PREPARED J. BRADLEY	DART AERO ACCESSORIES INC VICTORIA INTERNATIONAL AIRPORT, CANADA
APPROVED <i>[Signature]</i>	DEO 902 1 REV.: A SHEET 1 OF 22
DATE 94.11.17	Kwik-Float Ammendments

ENGINEERING ORDER

AMENDS STA SH92-65
AMENDS STC SH1057NE

FOR OPTIONAL FORWARD BELLY LOCATION OF GAS CYLINDERS

PLATE NO. 11-02-84	Drawn Number BHA/DRA/469-04
						Revised

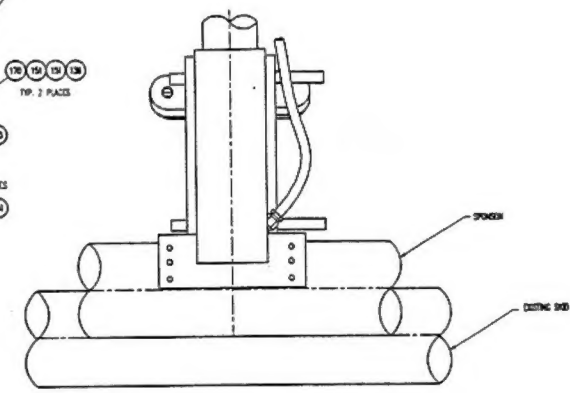
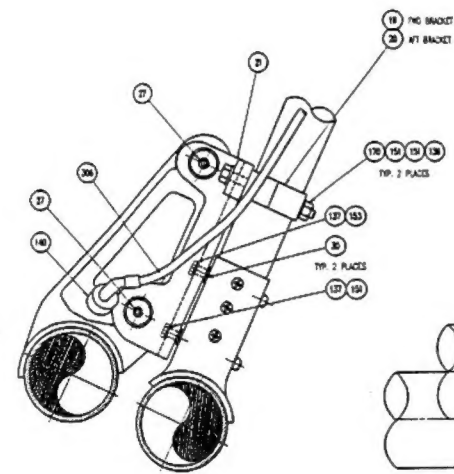
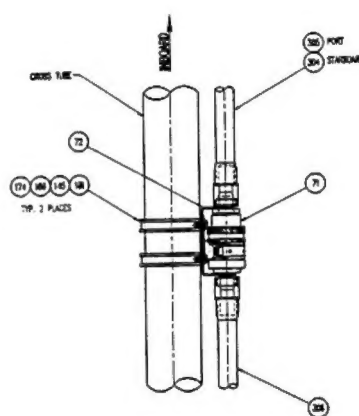
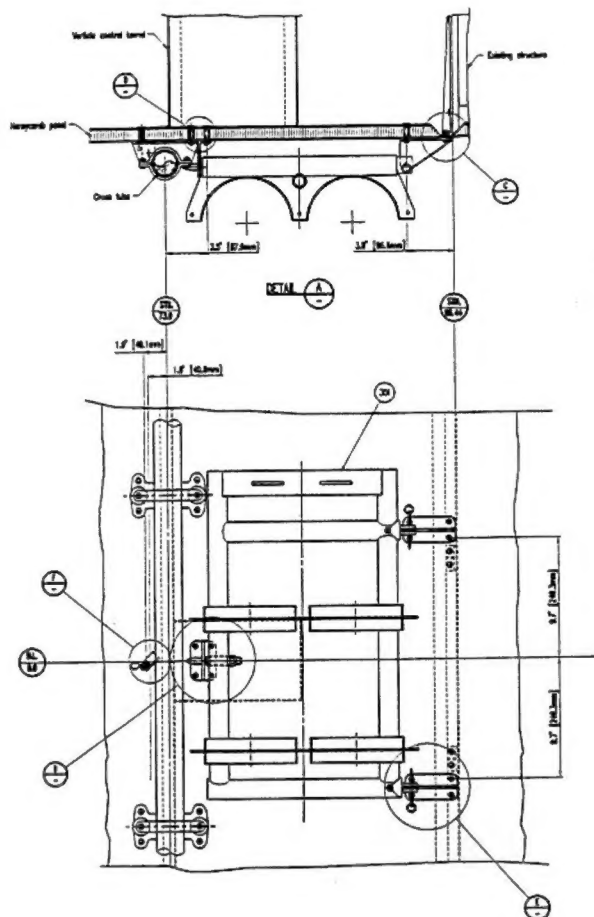
INCORPORATE Helitech Pty, Ltd. Drawing BHA/DRA/469 (Sheets 2-10 of DEO 9021)
